ADDENDUM NO. 1

DATE: 09/16/24

Child Nutrition Kitchen
726 South Pine St.
Madera, California 93637

DARDEN PROJECT NO. 2310
City of Madera Application #19876

FLOOR PLAN
Drawing

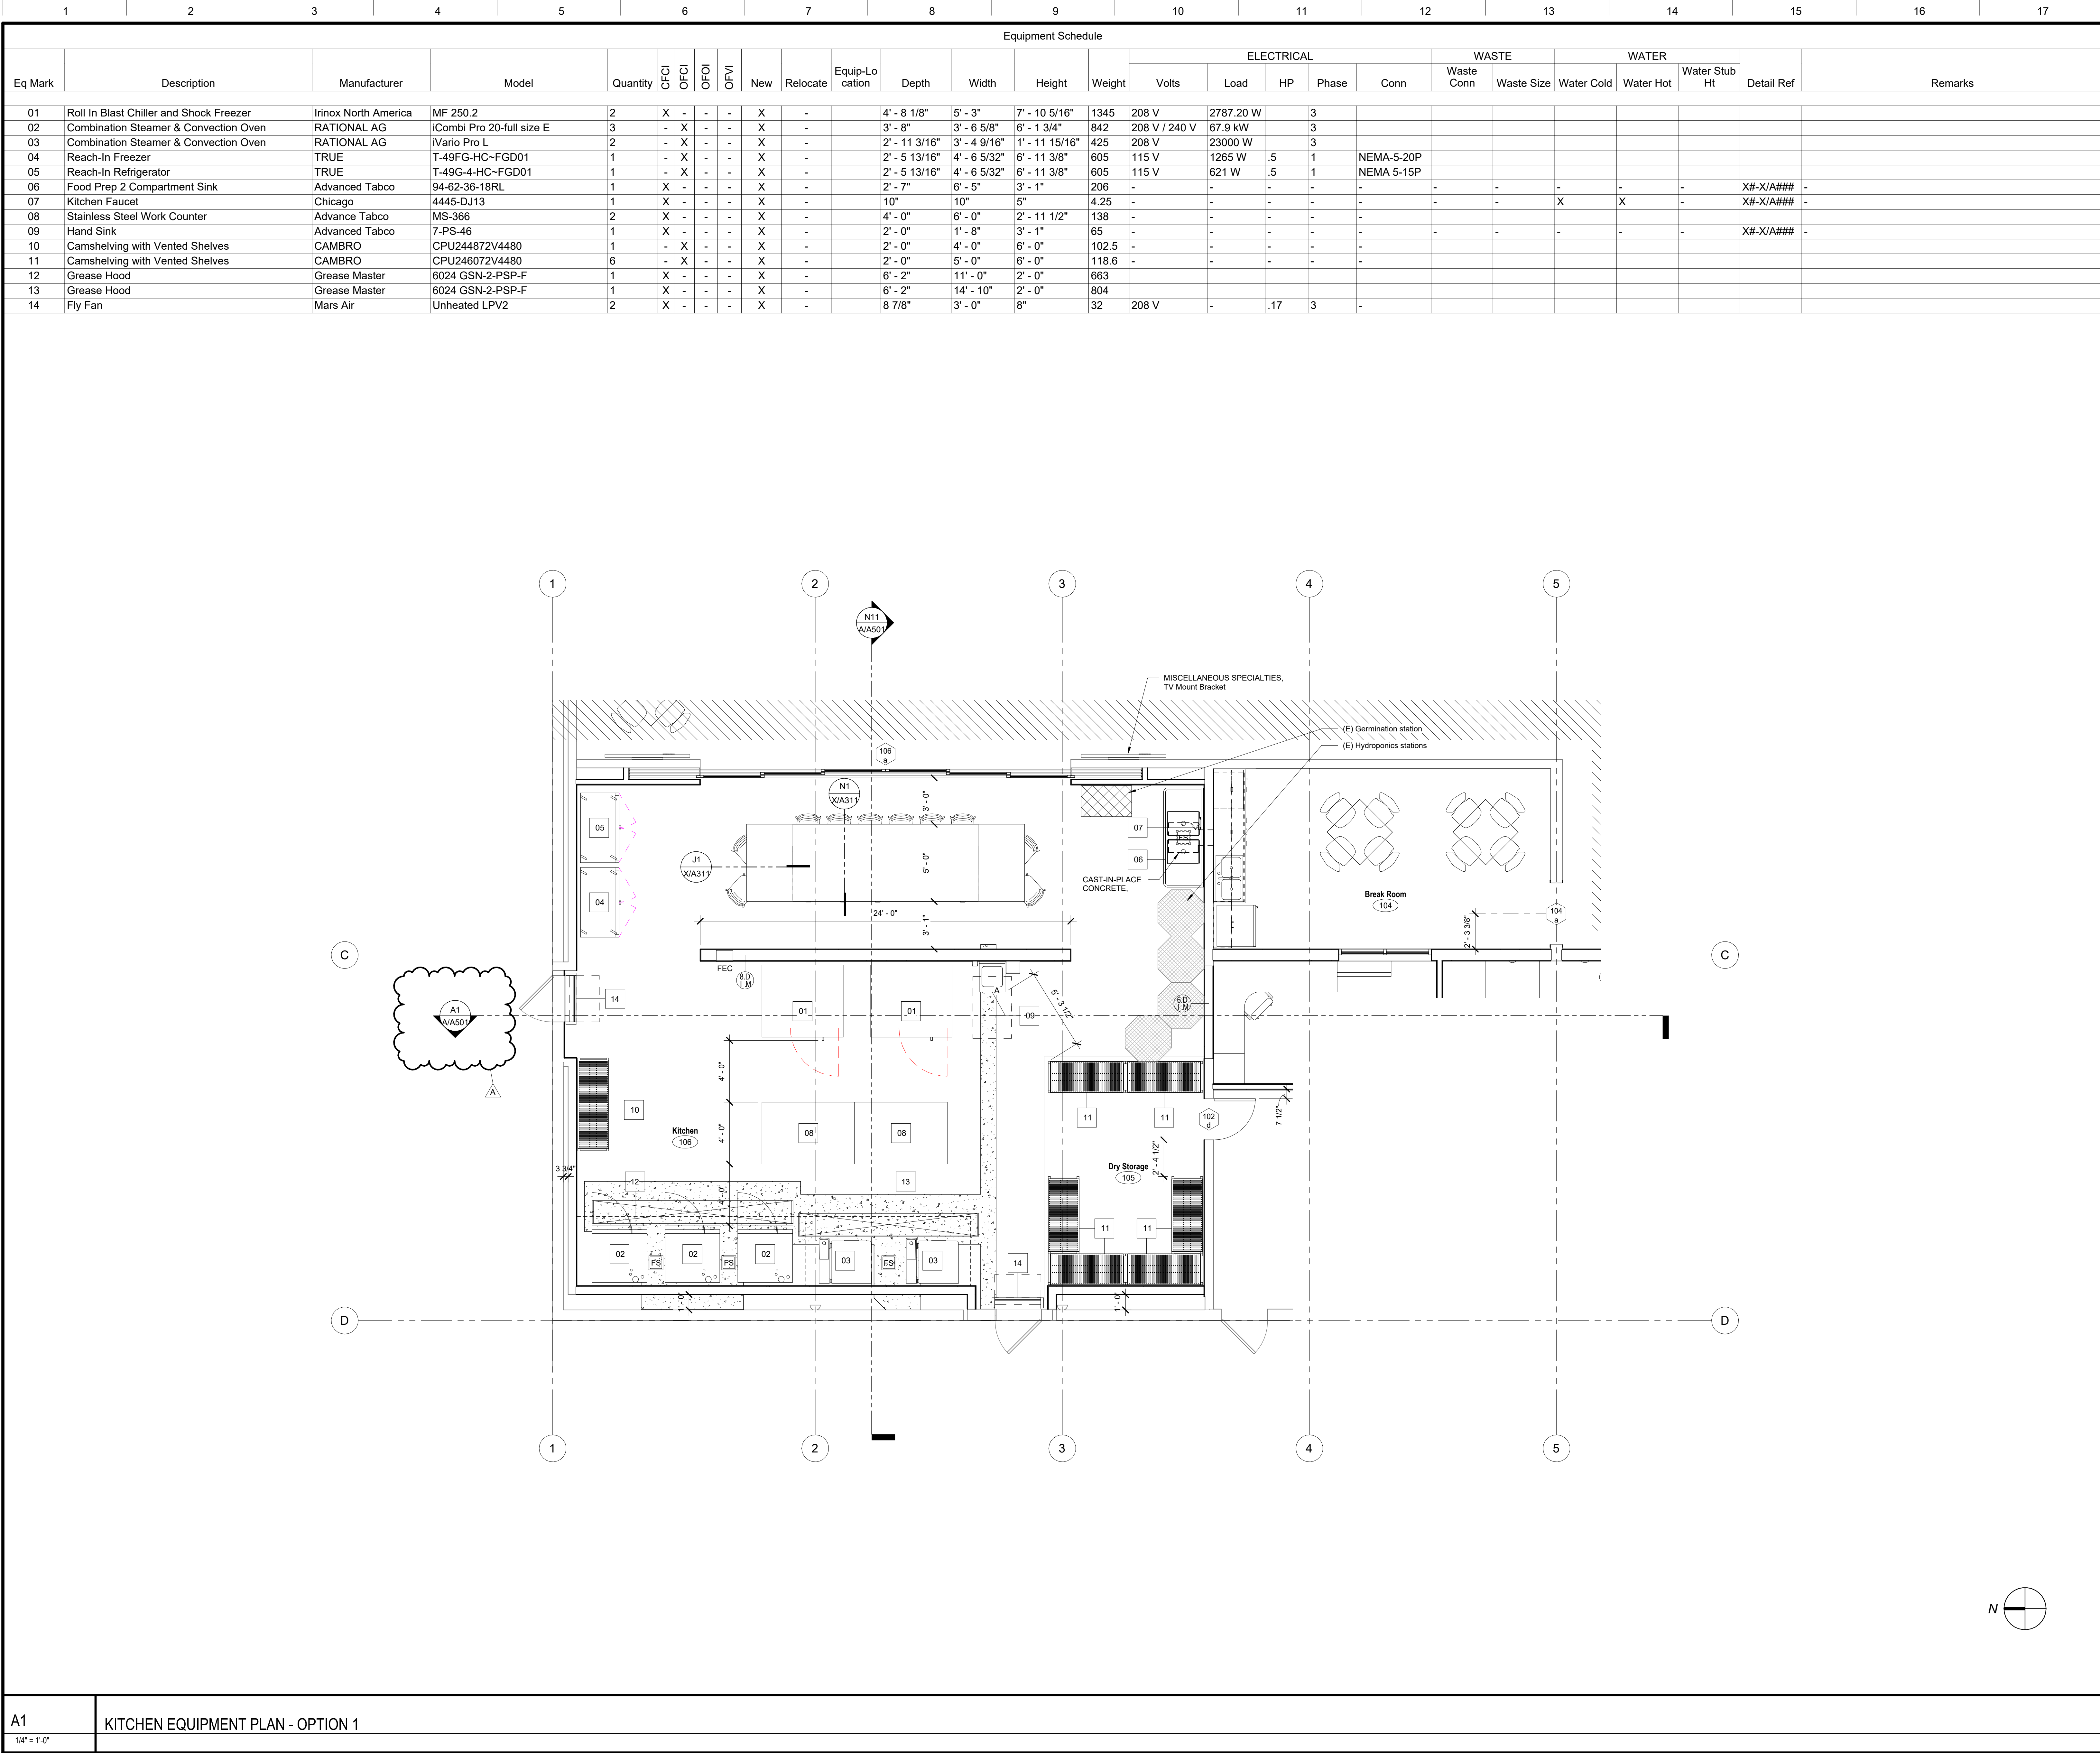
AD1-A04 Refer to Sheet A/A101, FLOOR PLAN:

1. Replace sheet with attached exhibit AD1-AX04
 - North/South section reference added.

A/A103

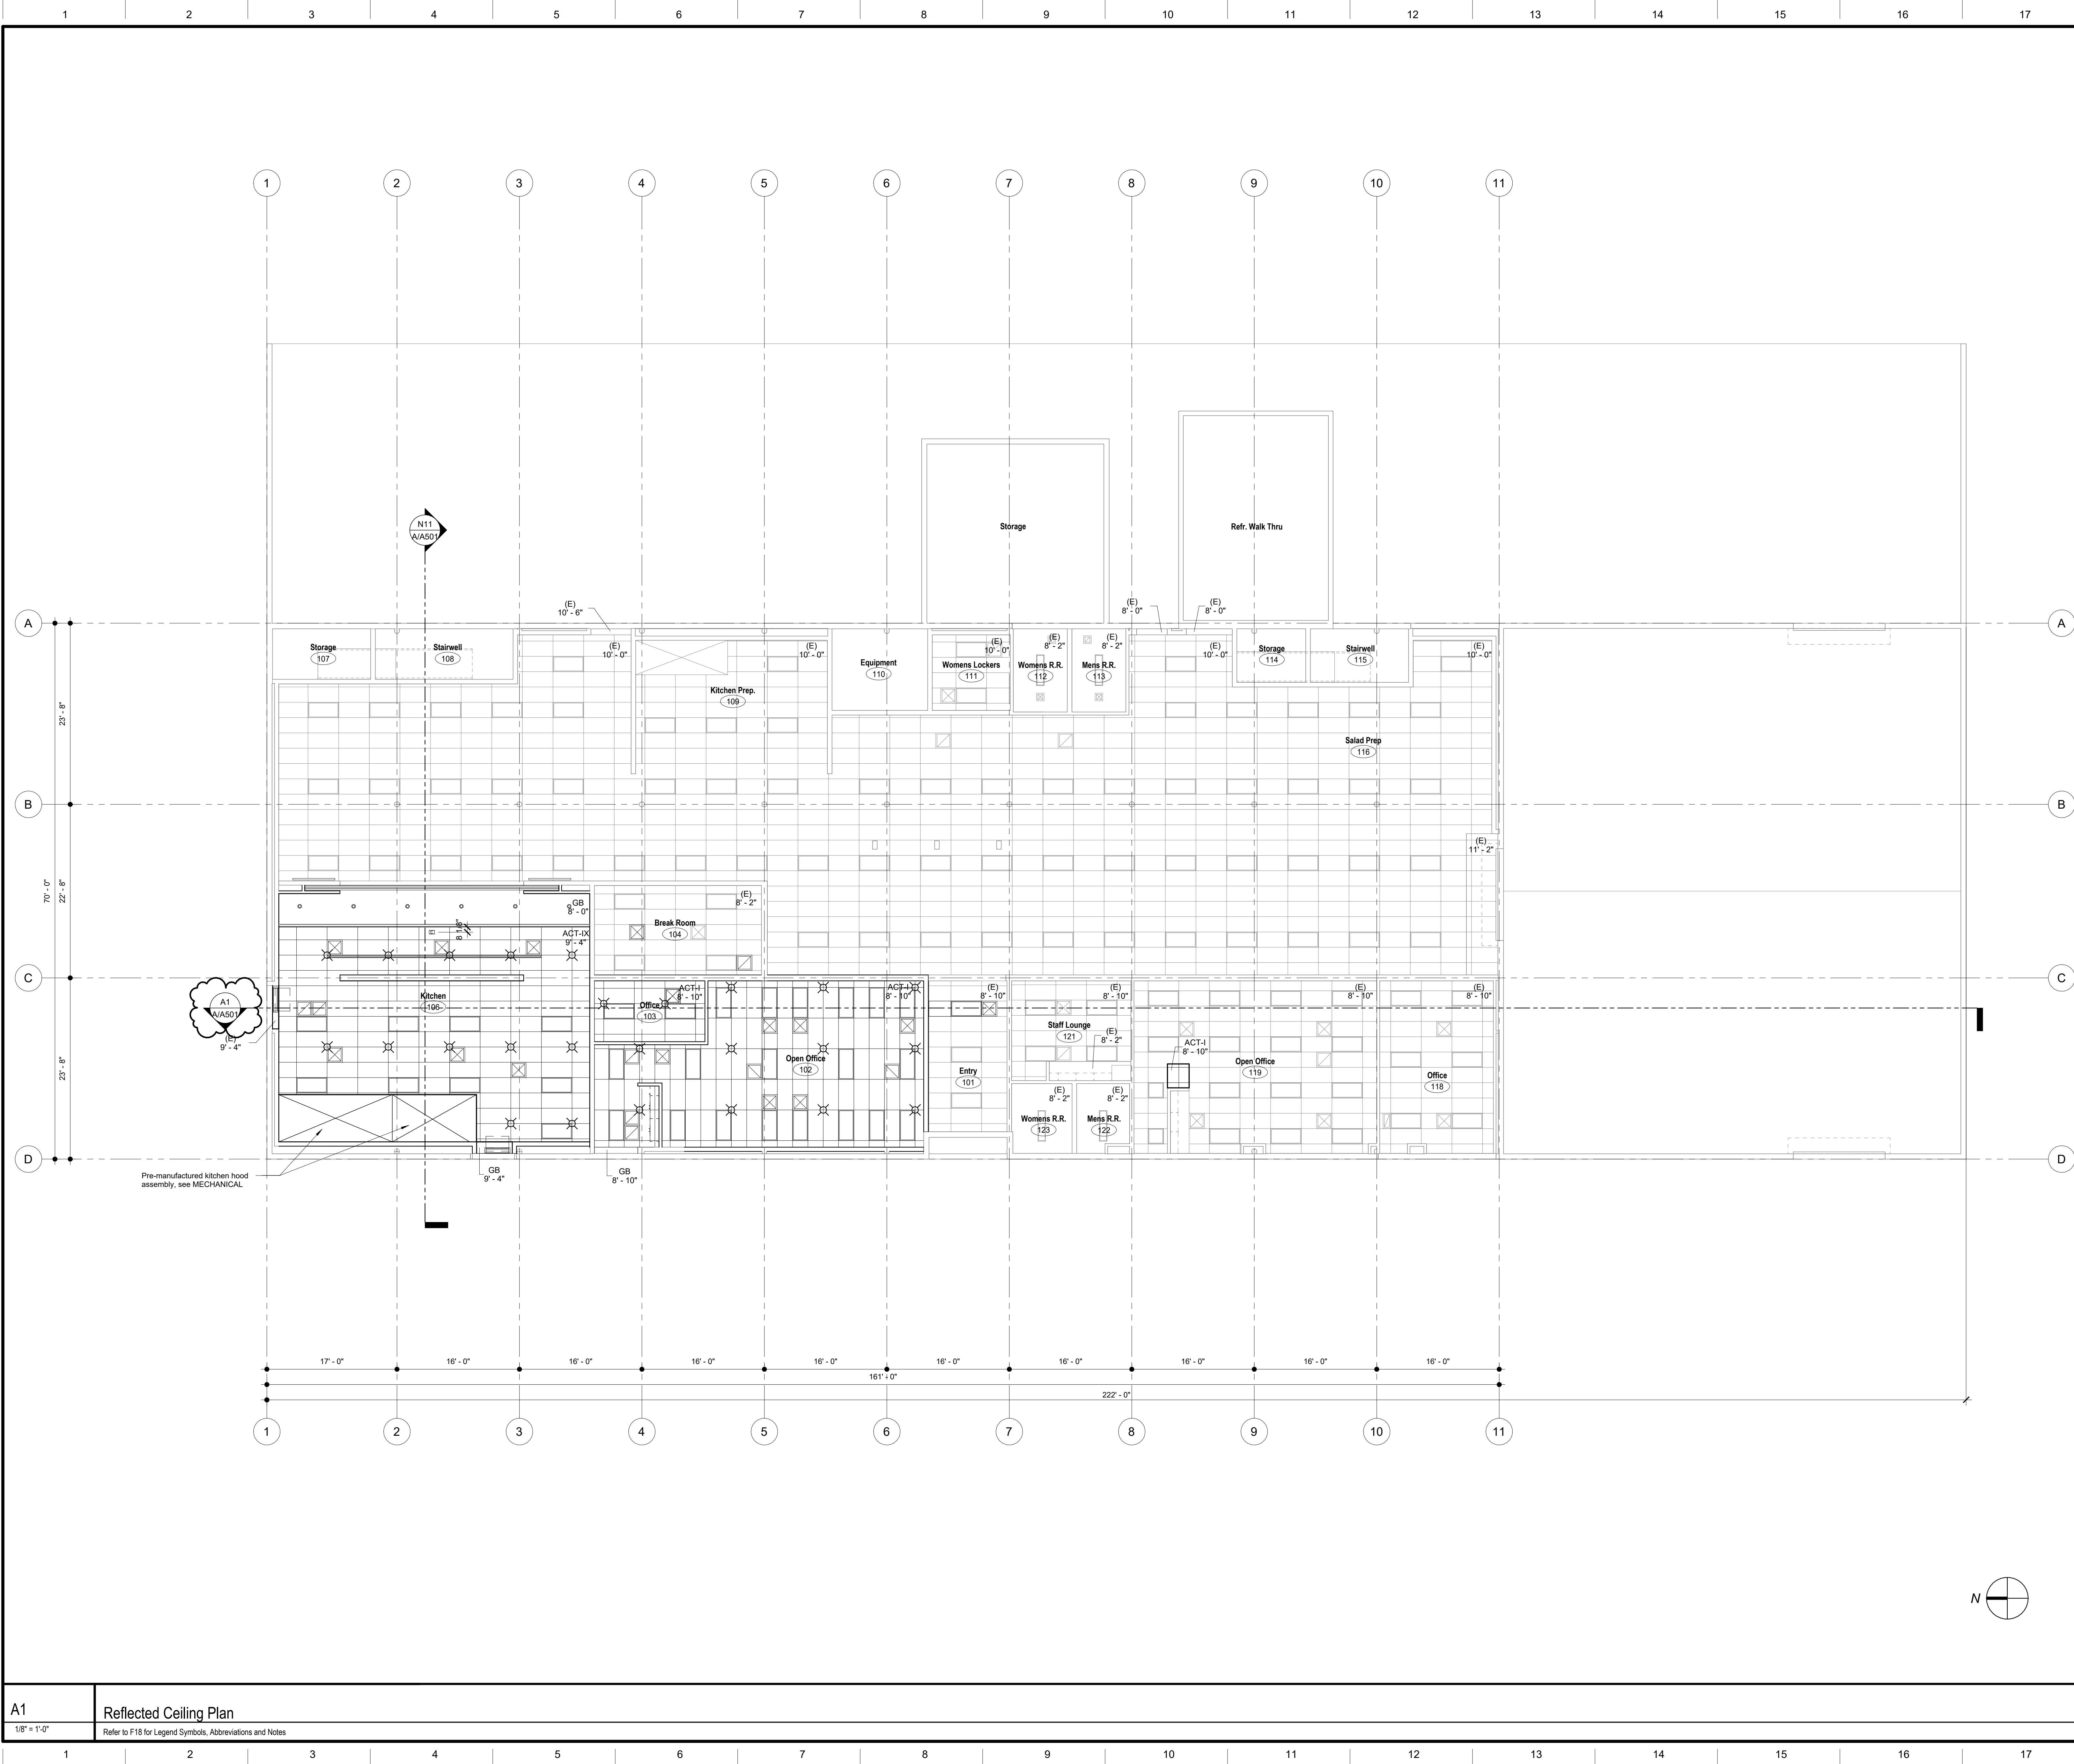
AD1-A06 Refer to Sheet A/A103, ENLARGED OFFICE PLANS:

1. Replace sheet with attached exhibit AD1-AX06
 1. North/South section reference added.

REFLECTED CEILING PLAN

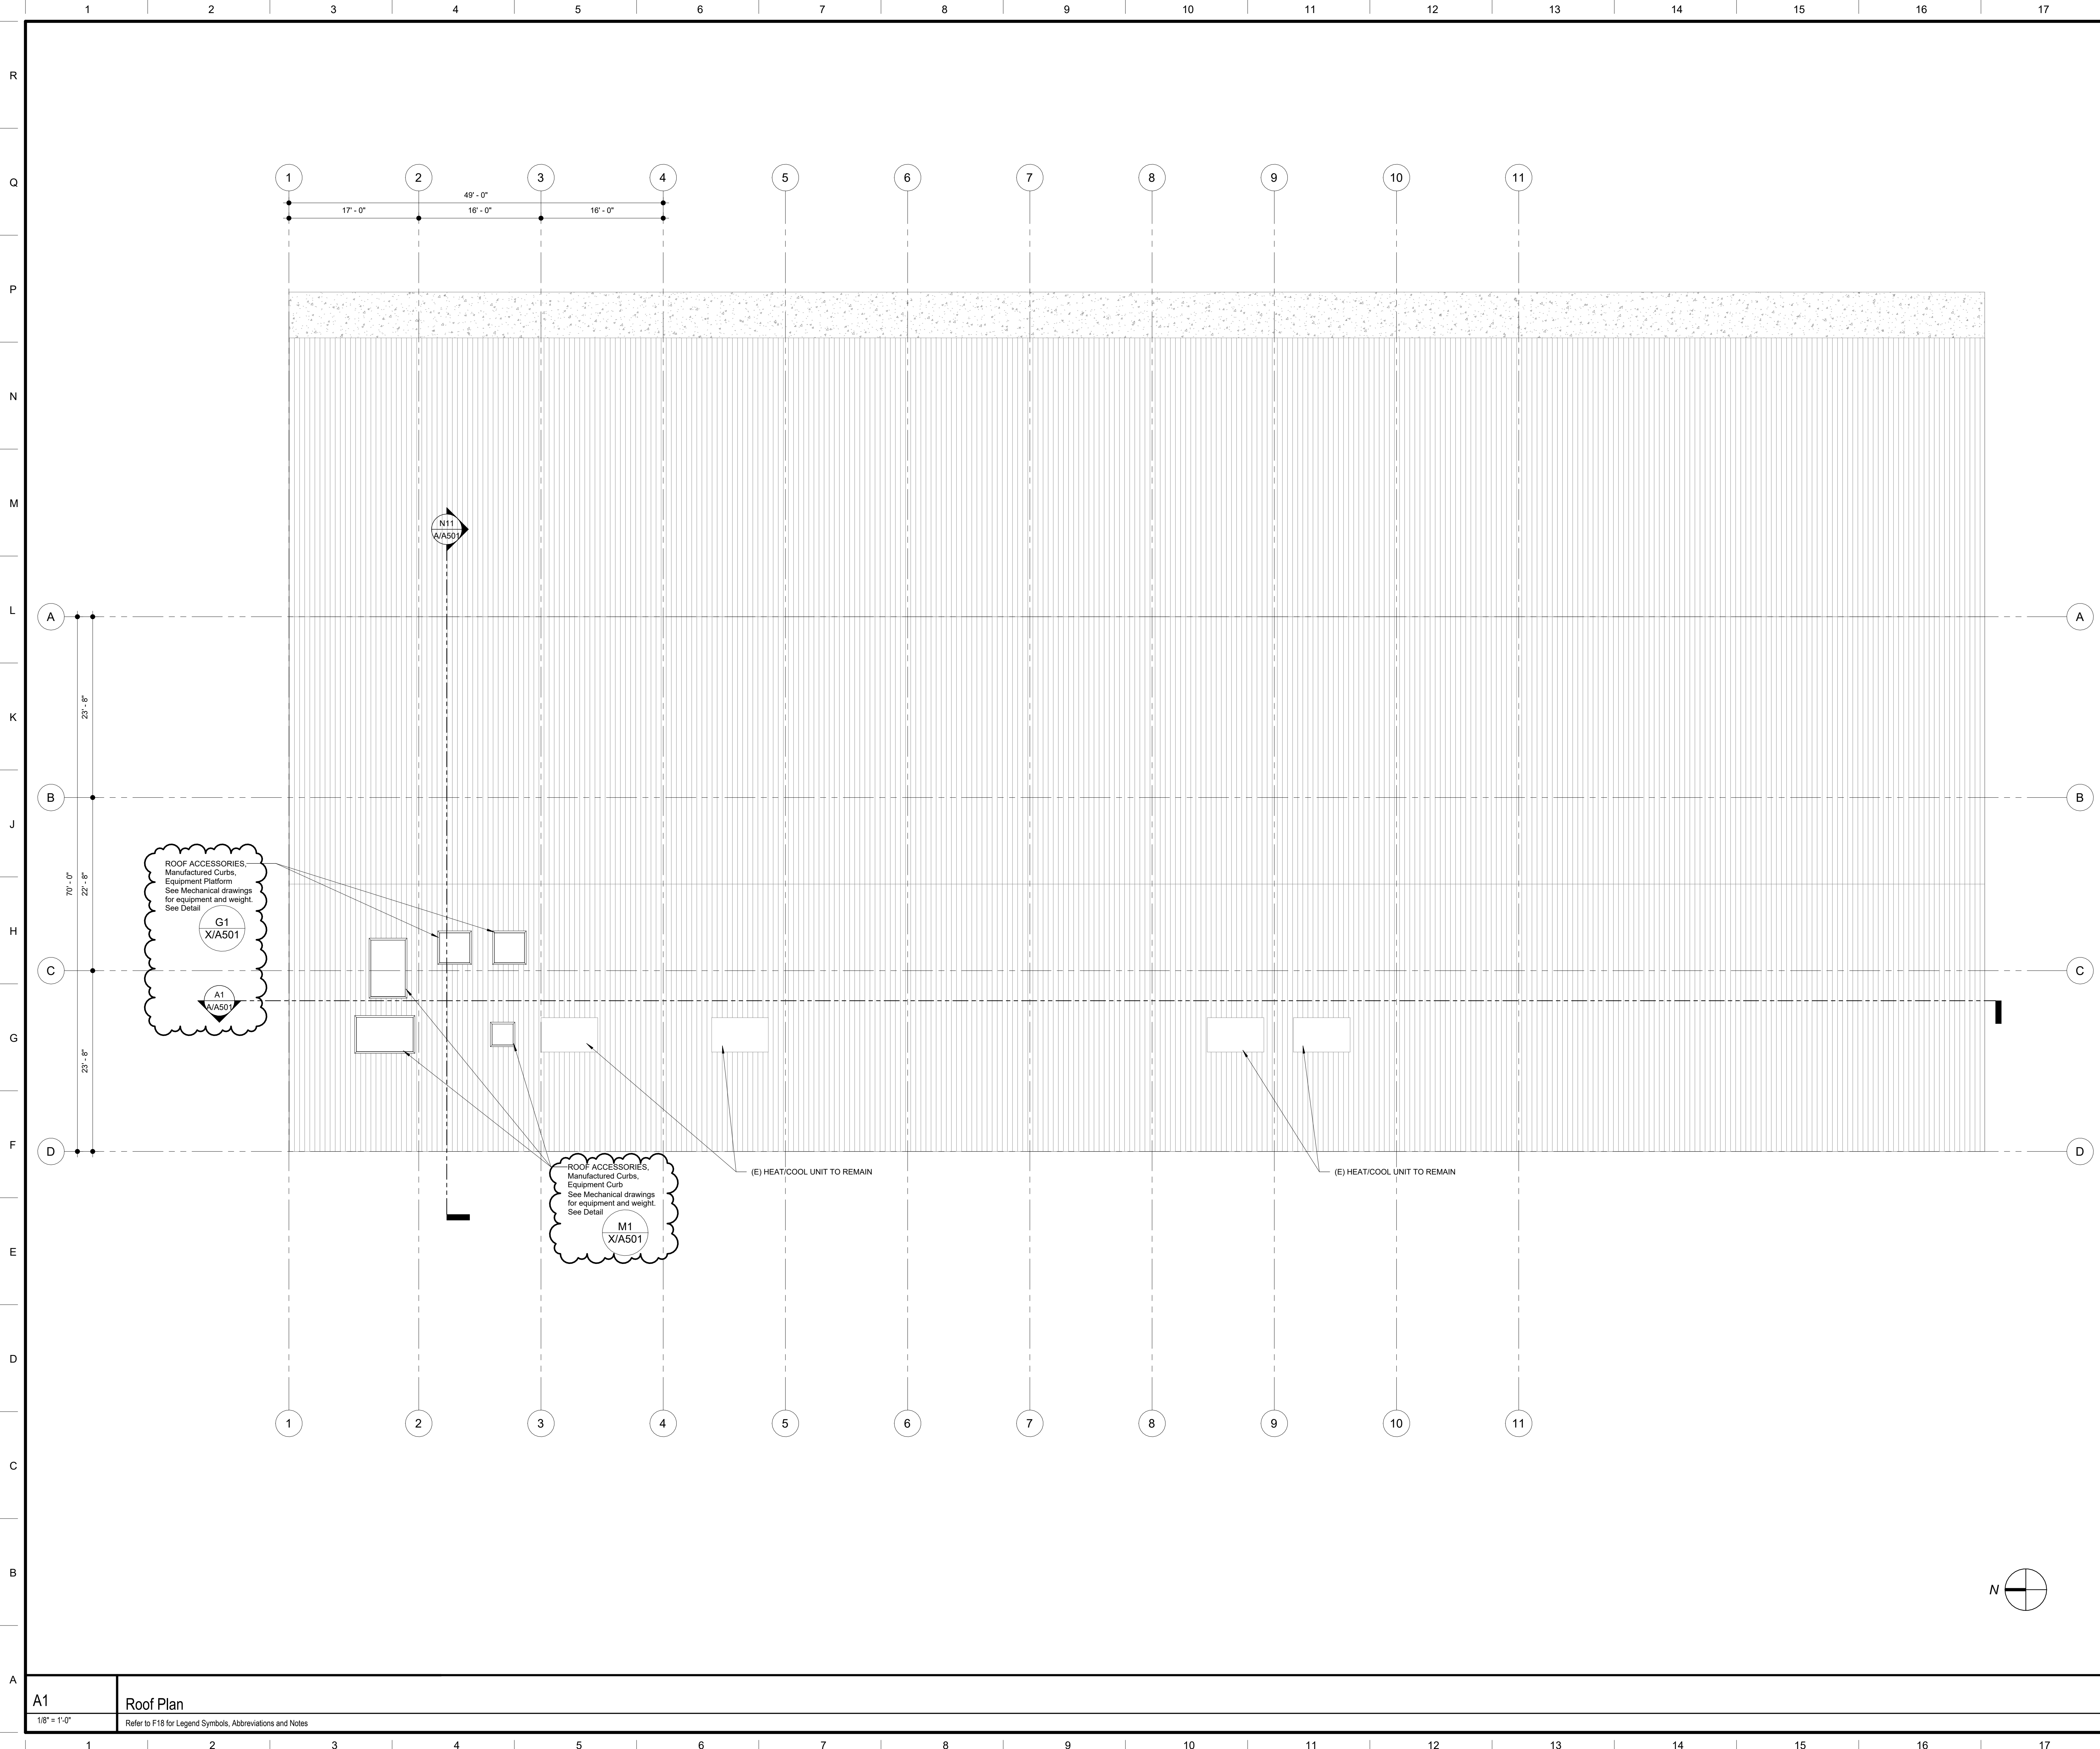
AD1-A07 Refer to Sheet A/A201, REFLECTED CEILING PLAN:

1. Replace sheet with attached exhibit AD1-AX07
 1. North/South section reference added.
